CITY OF PORTLAND

RE: 222 Riverside St.

Your application to make interior renovations 24° X 28° mezzanine, has been reviewed and a permit is herewith issued subject to the following requirements:

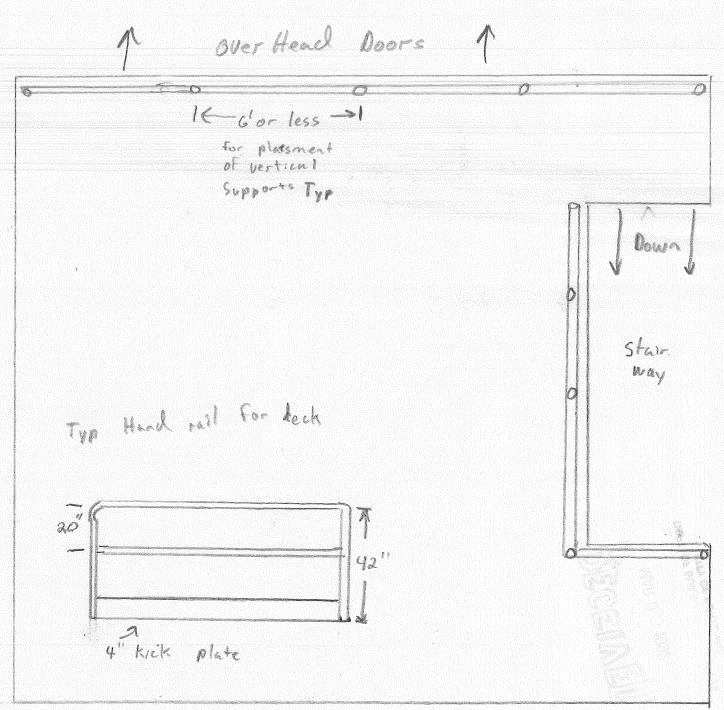
- 1. Stairs as shown on plan are not acceptable. 7" riser maximum and l1" tread minimum in the clear measured between the vertical planes of the foremost projection of adjacent treads.
- Use is approved for storage only.
- 3. This plan does not show the live load capacity of the proposed storage area. Please submit this information for approval, either 125 PSF for light storage, or 250 PSF for heavy storage.
